VIRGINIA ELECTRIC AND POWER COMPANY (DOMINION)
SURRY AND NORTH ANNA POWER STATIONS UNITS 1 AND 2
REQUEST FOR ADDITIONAL INFORMATION – RE: STATION BLACKOUT AND
NON-EQ CABLE MONITORING PROGRAM
LICENSE RENEWAL APPLICATIONS

**License Renewal – Revised Response to RAI 2.5-1
Serial No. 02-297**

**Surry and North Anna Power Stations, Units 1 and 2
License Renewal Applications**

**Figure SPS-1
 Surry Power Station**

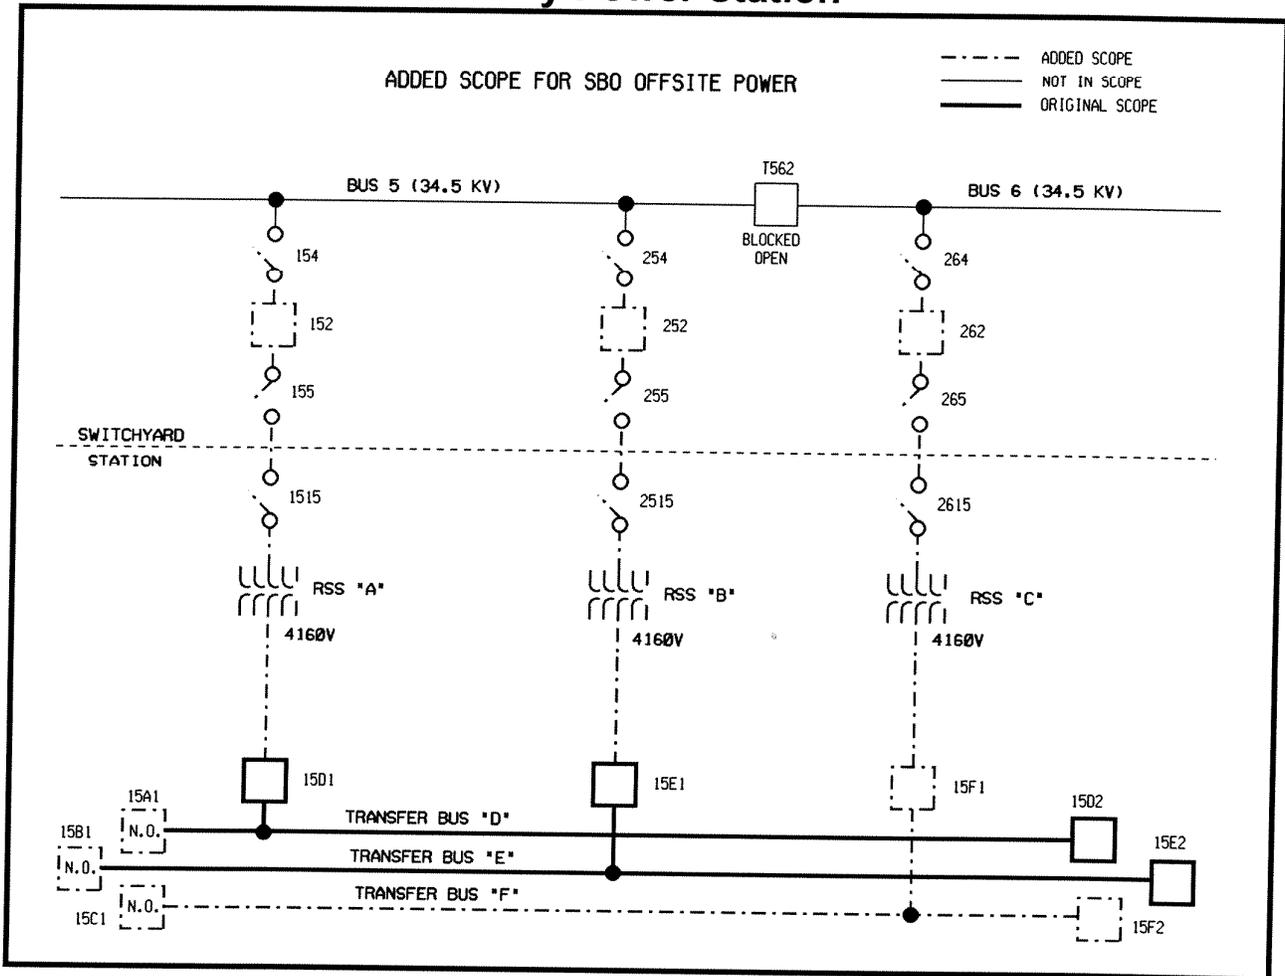
The screening results in both license renewal application (LRA) for Section 2.5 do not include any electrical components listed in NEI 95-10 (Appendix B) and the Standard Review Plan (Table 2.1-5) associated with the offsite power system. These are components such as switchyard bus, transmission conductors, switchyard insulators and transmission line insulators. 10 CFR 54.4(a)(3) requires that all systems, structures, and components (SSCs) relied on in safety analyses or plant evaluations to perform a function that demonstrates compliance with the Commission's regulation for station blackout (10 CFR 50.63) be included within the scope of Part 54. In 10 CFR 50.63 it's required that each light-water-cooled nuclear power plant licensed to operate be able to withstand and recover from a station blackout of a specified duration that is based upon factors that include the expected frequency of loss of offsite power and the probable time needed to recover offsite power. At North Anna and Surry the specified duration was determined based upon evaluations that followed the guidance in NRC Regulatory Guide 1.155 and NUMARC 87-00, and included the plants' offsite power characteristics. These characteristics helped determine the probable time needed to recover offsite power (coping duration). The resulting four hour coping duration at North Anna and Surry is, therefore, based on the likelihood of recovering offsite power within four hours following its loss. Therefore, identify where in the LRA these Station Blackout SSCs are included within the scope of license renewal, or provide a technical justification for excluding the Station Blackout SSCs from the screening results.

For Surry, the additional offsite power path scope required to recover from an SBO event extends from the switchyard disconnect switches through the 34.5KV circuit breakers to the RSSTs and continues to Transfer Buses D, E, and F. Transfer Buses D and E and their associated 4160V circuit breakers and controls are already within the SBO equipment scope of license renewal. Figure SPS-1 provides an excerpt from the Surry one-line integrated schematic electrical drawing and shows the boundary of the additional SBO offsite power path scope.
